Planning reference: 3/2025/0141

Location: Bolton Fold Farm, Alston Lane, Longridge, PR3 3BN

Proposal: Regularisation of erection of three commercial buildings (10 commercial units Use Class E) and associated works

We refer to the letter from the Lead Local Flood Authority (LLFA) dated 12th August 2025 in which the LLFA had no objection in principle to the above application, subject to the evidence outlined below being provided. Our responses are alongside.

PROPOSED SURFACE WATER DRAINAGE LAYOUT

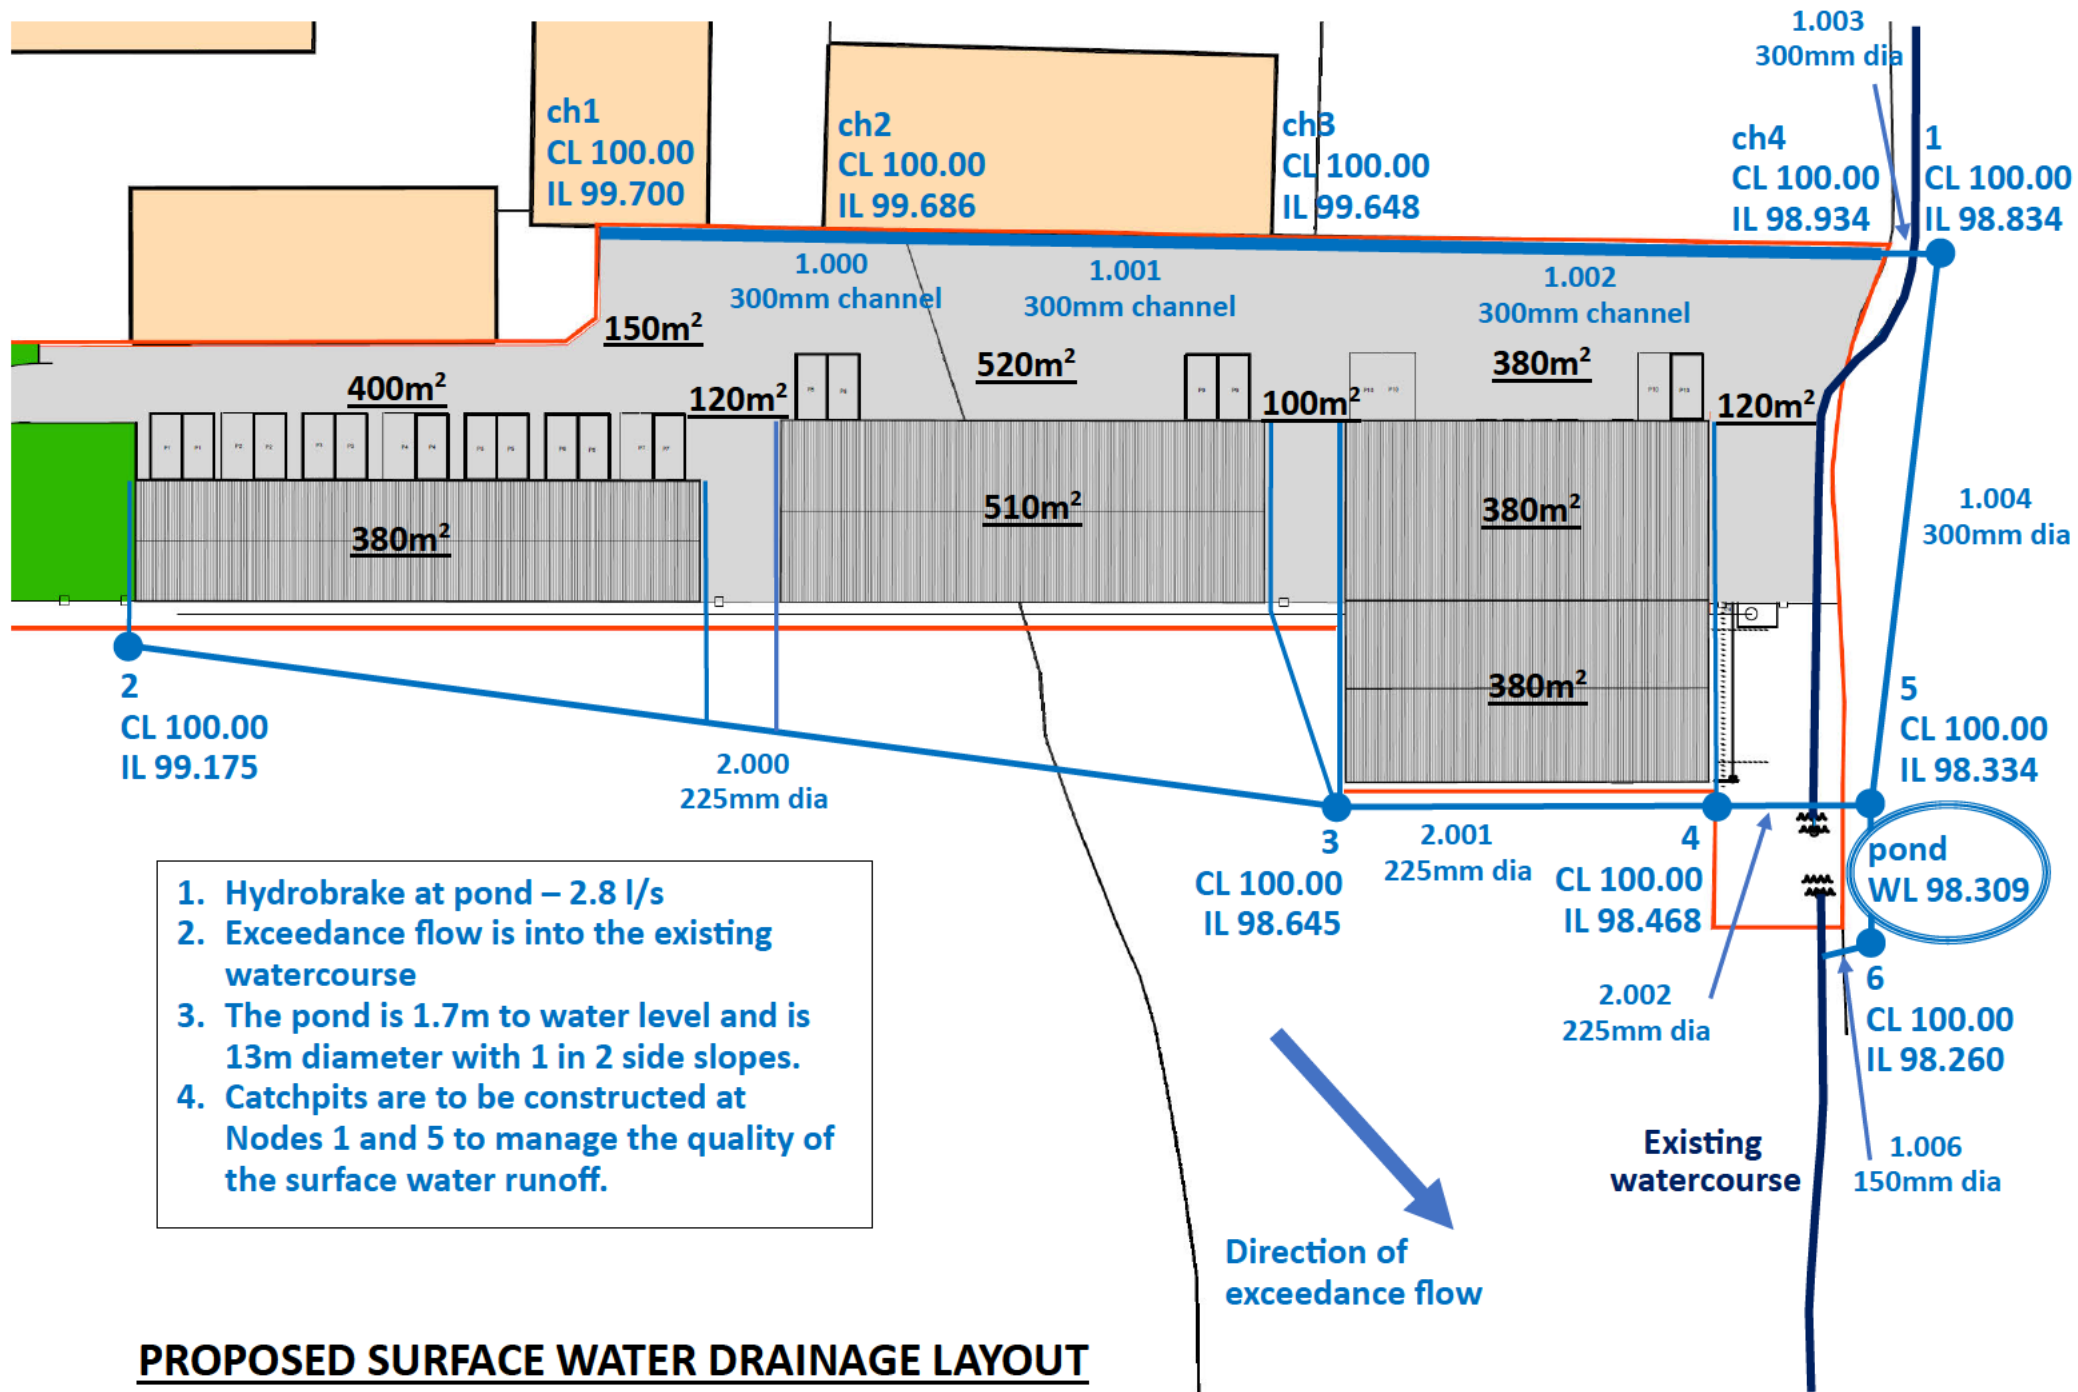
b) Final sustainable drainage plans appropriately labelled to include, as a minimum:

- i. Site plan showing all permeable and impermeable areas that contribute to the drainage network either directly or indirectly, including surface water flows from outside the curtilage as necessary;

- ii. Final detailed sustainable drainage system layout showing all pipe and structure references, dimensions and design levels;
- iii. Details of all sustainable drainage components, including landscape drawings showing topography and slope gradient as appropriate;

- iv. Drainage plan showing flood water exceedance routes in accordance with Defra Technical Standards for Sustainable Drainage Systems;
- v. Details of proposals to collect and mitigate surface water runoff from the development boundary;

- vi. Measures taken to manage the quality of the surface water runoff to prevent pollution, protect groundwater and surface waters, and delivers suitably clean water to sustainable drainage components;

Response: The drainage plan has been updated with the above information and is attached to this letter.

1. Hydrobrake at pond – 2.8 l/s
2. Exceedance flow is into the existing watercourse
3. The pond is 1.7m to water level and is 13m diameter with 1 in 2 side slopes.
4. Catchpits are to be constructed at Nodes 1 and 5 to manage the quality of the surface water runoff.
